RE: Building Permit Application B00140960
7381 Hopkins Way
Proposed Addition

PROPERTY OF
NELSON E. YATES
 5TH ELECTION DISTRICT HOWARD COUNTY, MARYLAND
 JULY 17, 1977 SCALE: 1" = 50'

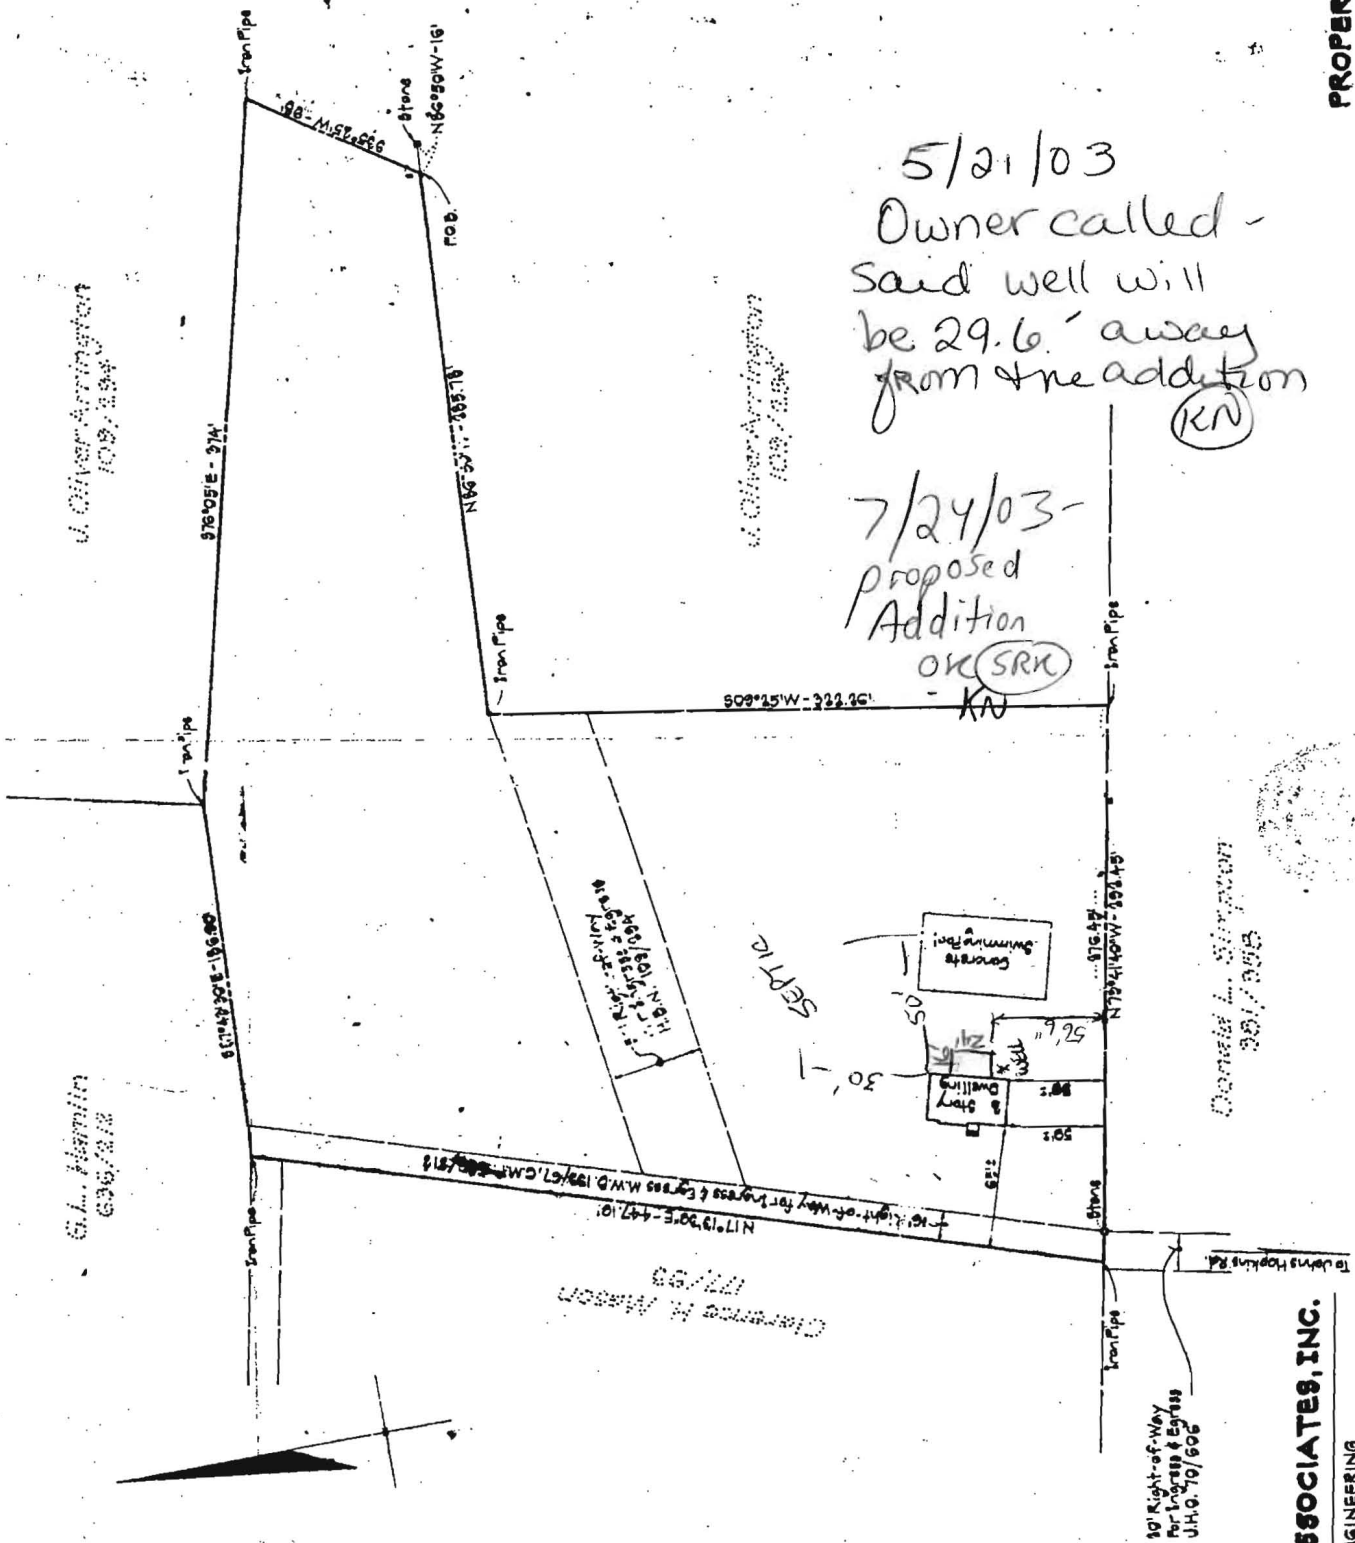
5/21/03
 Owner called -
 Said well will
 be 29.6' away
 from the addition
 (KN)

7/24/03 -
 Proposed
 Addition
 OK (SRK)
 KN
